ADDENDUM NO. 04 (MEPT)

Date of Issuance: April, 23, 2026

Project: **Replacement Elementary on Mustang Rd.**
Alvin Independent School District

Texas Arcadis Inc.
Project No.: 202502 - 30268973

AIR DISTRIBUTION -
LEVEL 2 AREA A

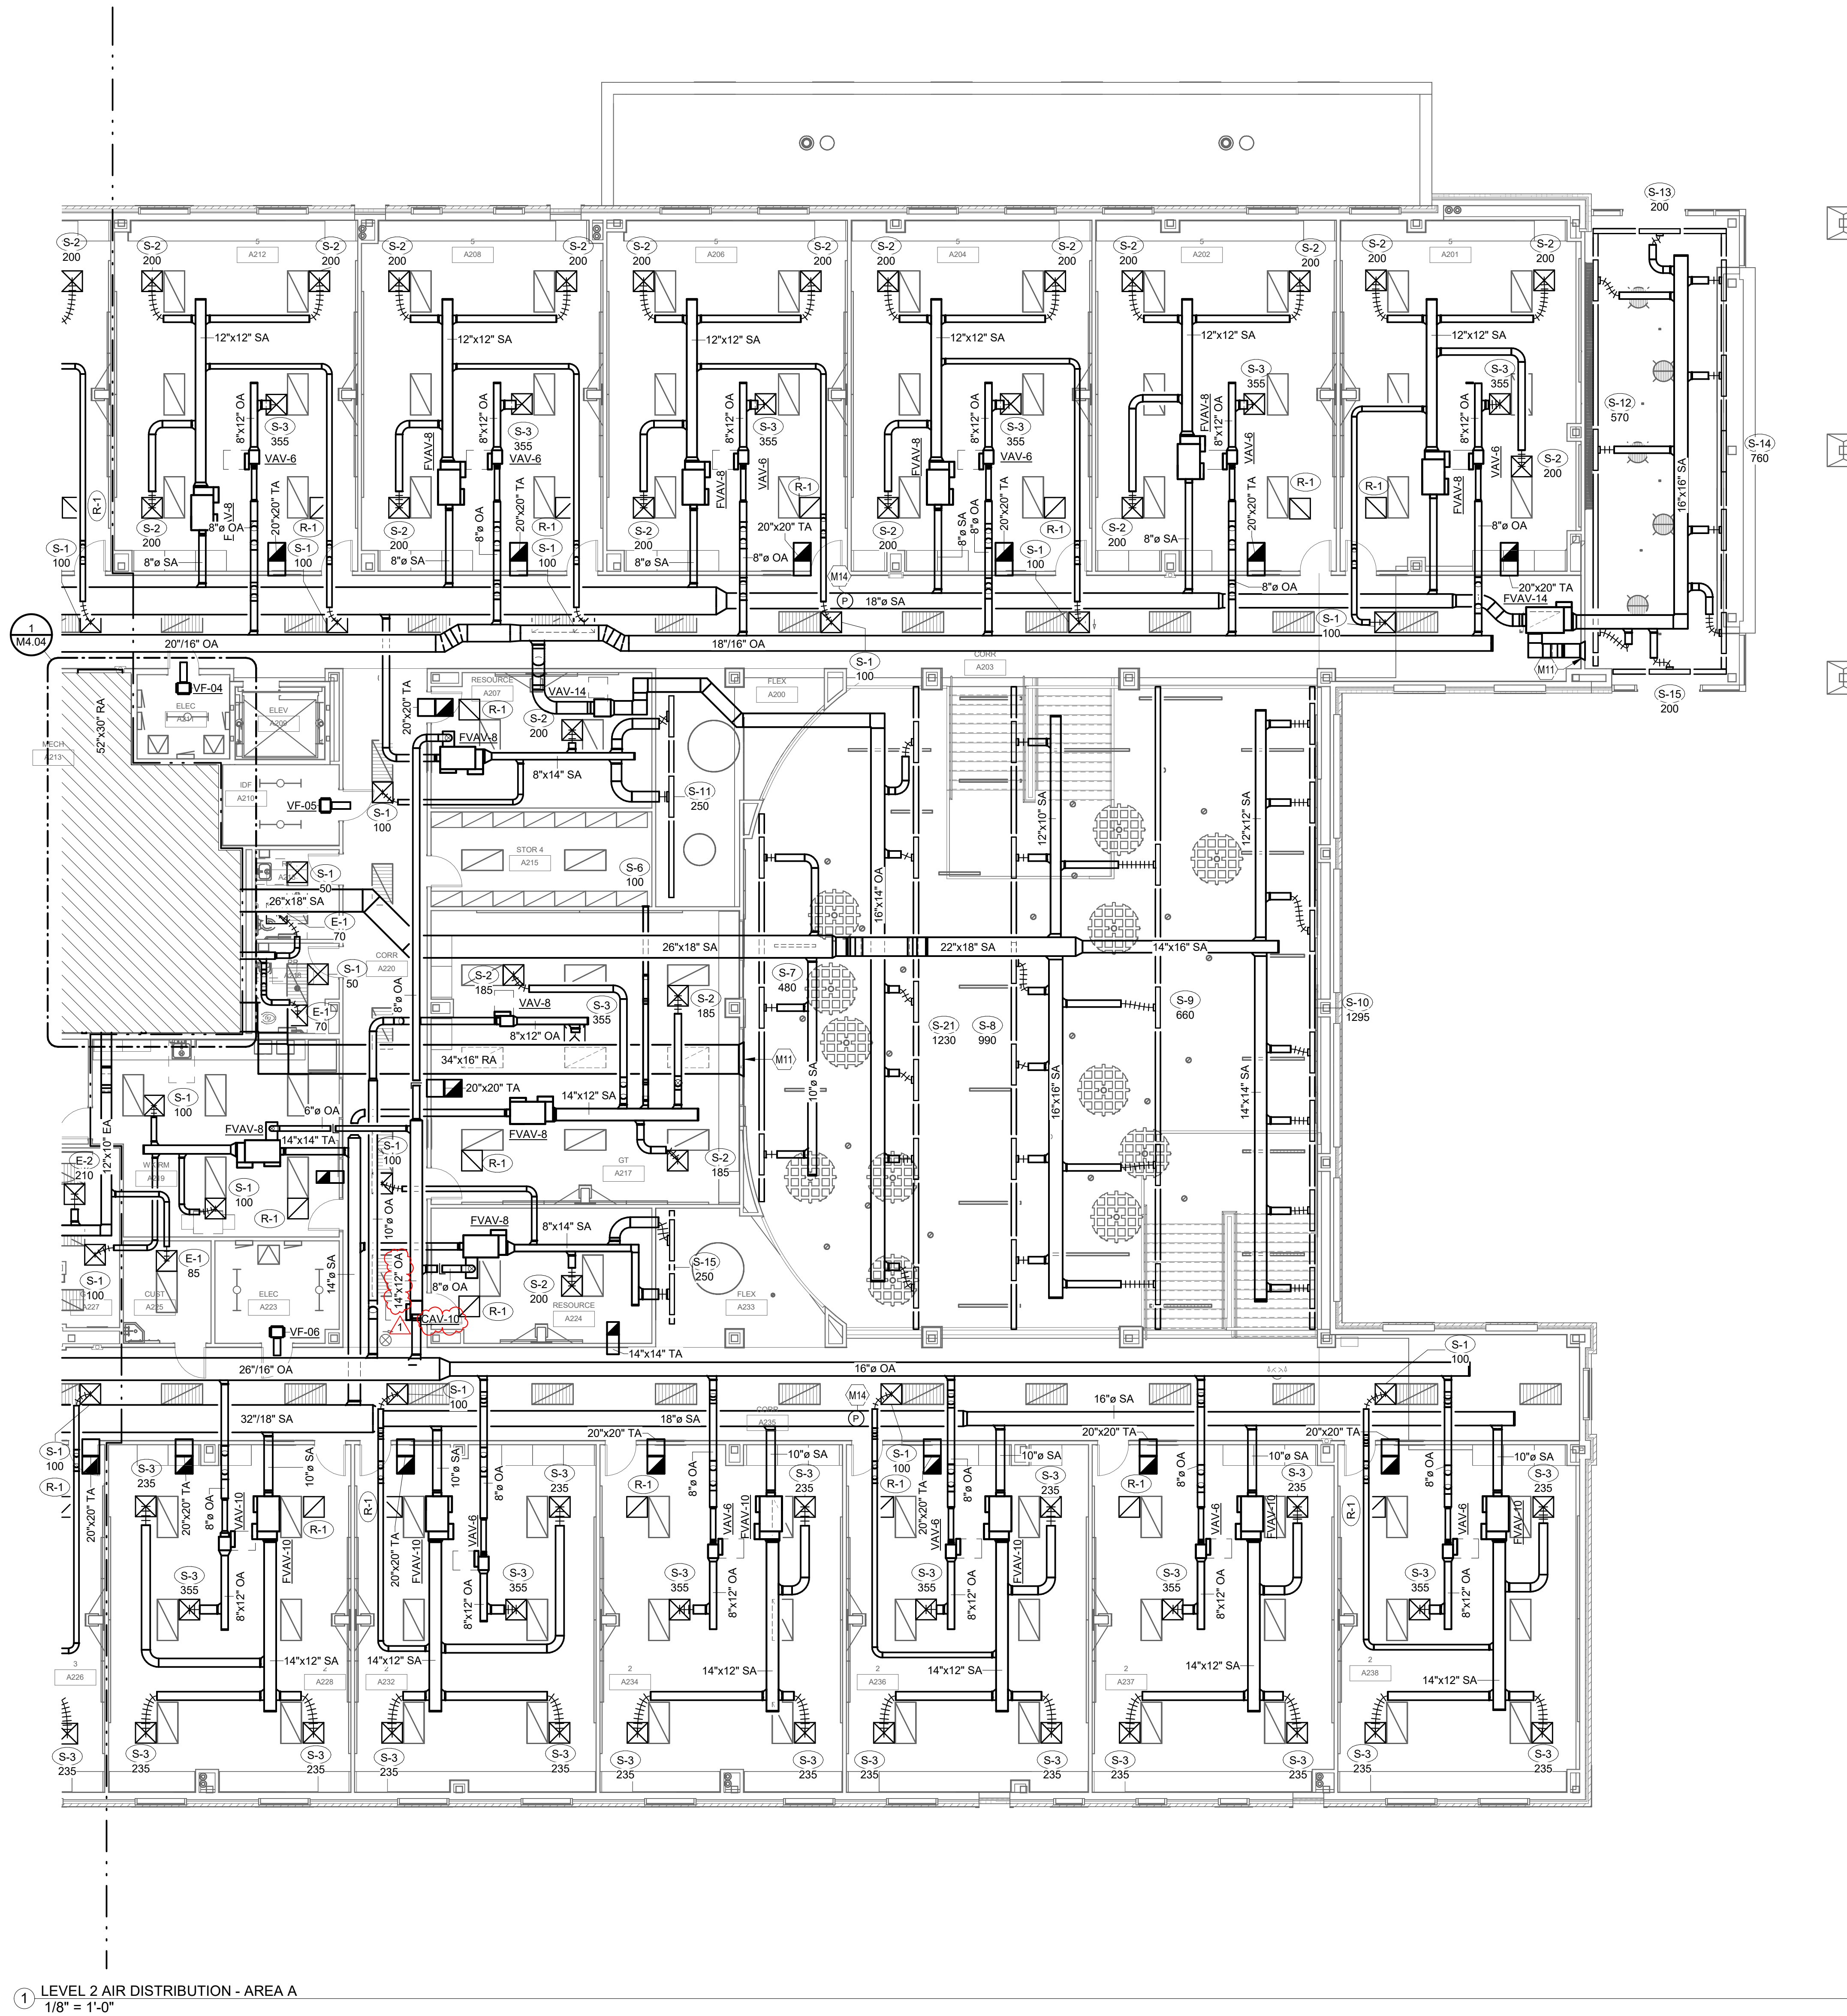
39. Sheet P7.01 – PLUMBING RISER - NATURAL GAS
 - l. Revised riser.
40. Sheet M2.05 – AIR DISTRIBUTION – LEVEL 2 AREA A
 - m. Adjust CAV Box size and associated ductwork.

AIR DISTRIBUTION -
LEVEL 2 AREA D

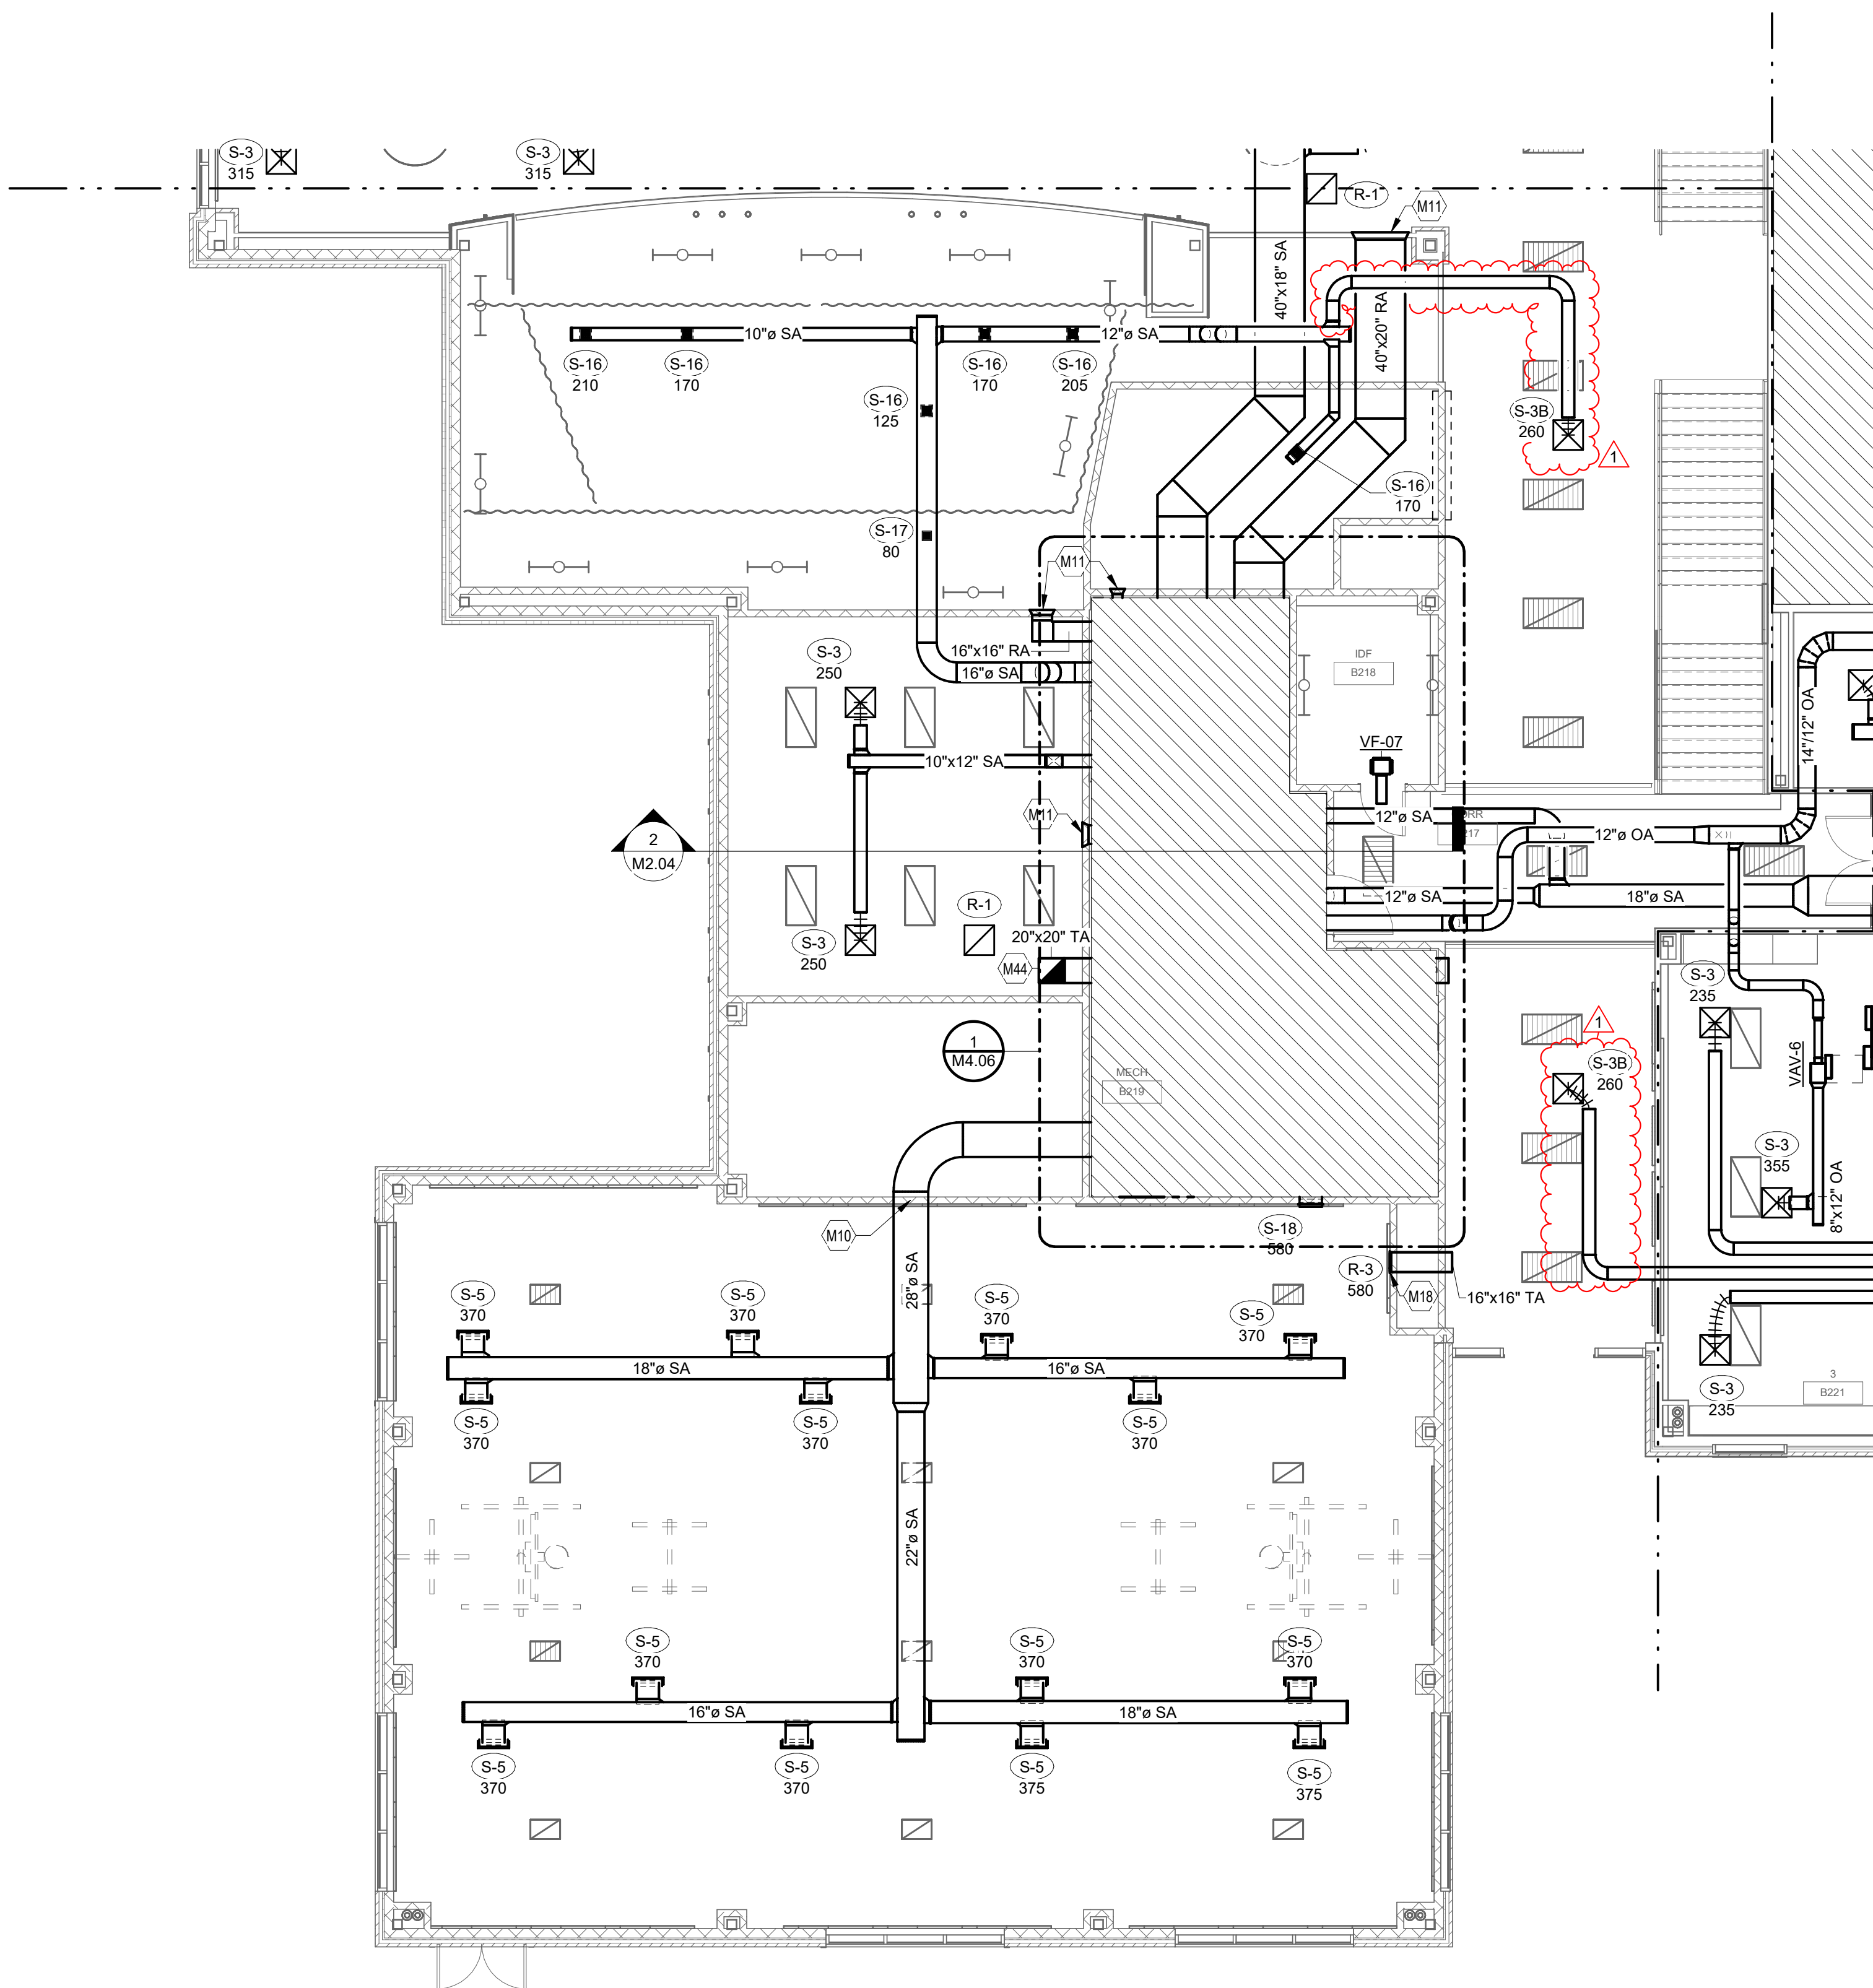
41. Sheet M2.08 – AIR DISTRIBUTION – LEVEL 2 AREA D
 - a. Added supply air duct tap and diffuser S-3B
 - b. S-1B supply air diffuser updated to S-3B diffuser and ductwork sizes adjusted.

① ENLARGED MECHANICAL ROOM - CENTRAL PLANT
1/4" = 1'-0"

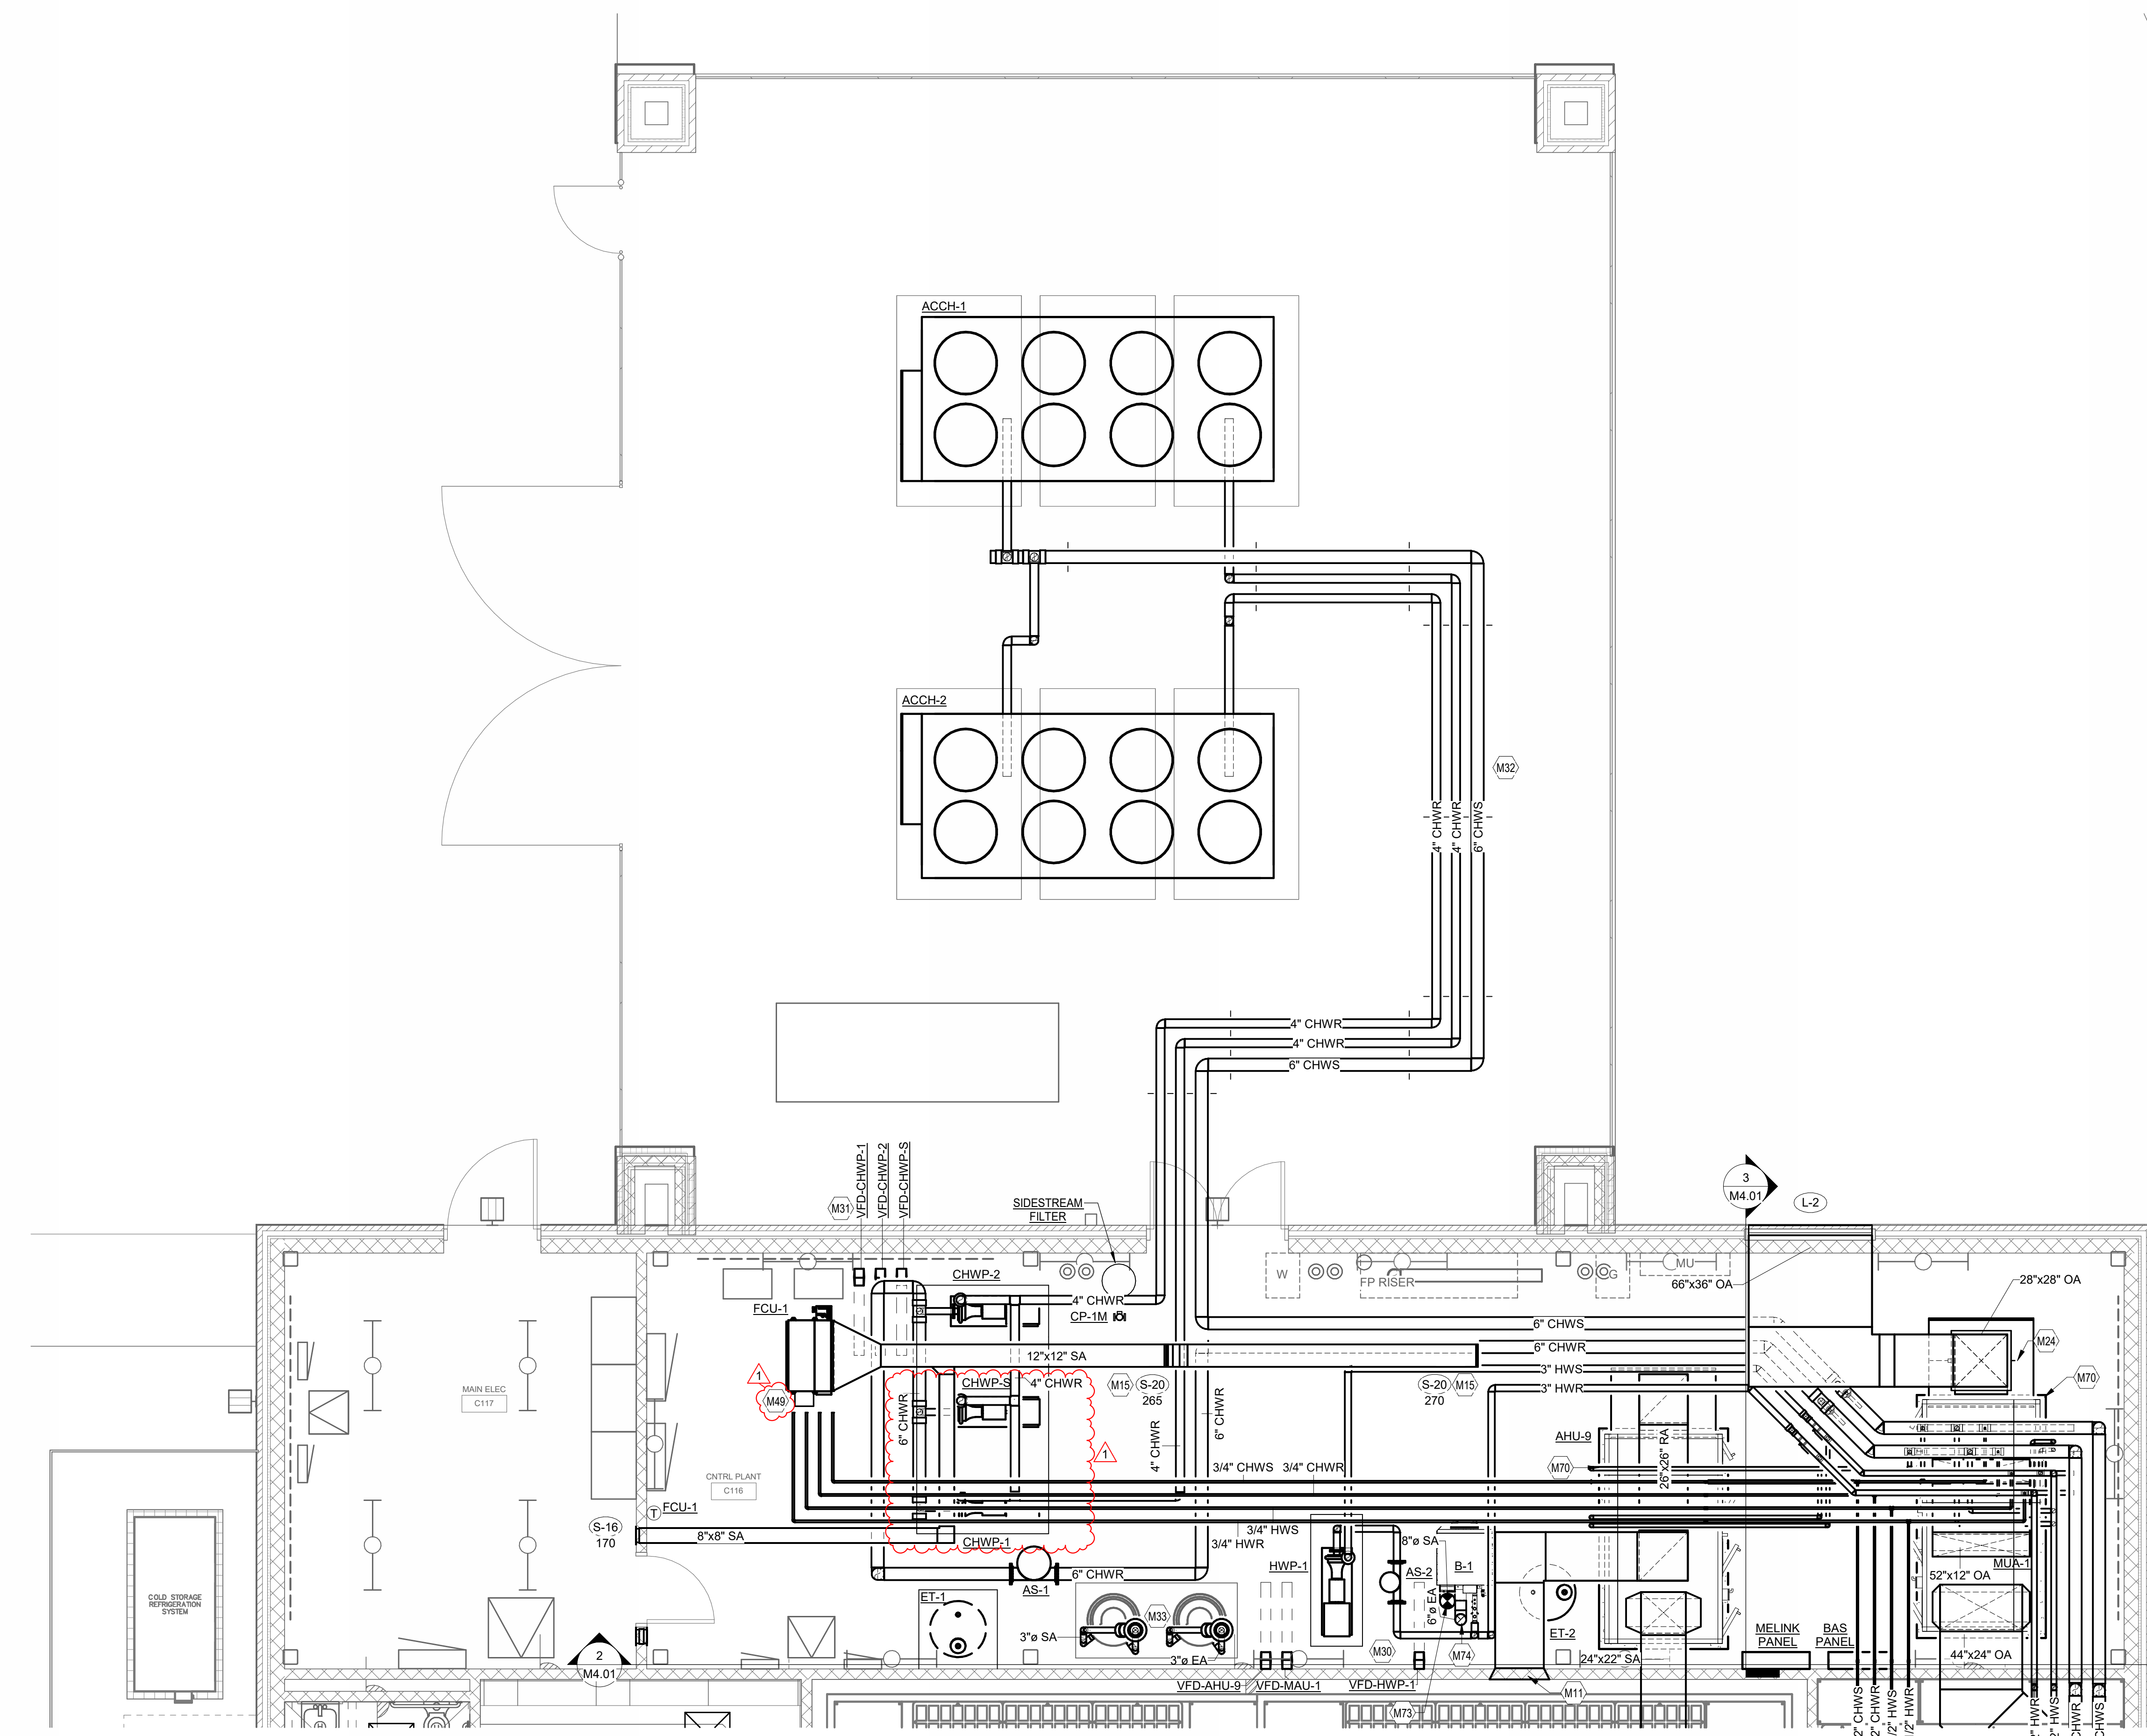
42. Sheet M4.01 – ENLARGED MECHANICAL ROOM – CENTRAL PLANT
 - a. Adjusted spacing between Chilled Water Pumps.
 - b. Added Keynote addressing FCU-1 Condensate routing.
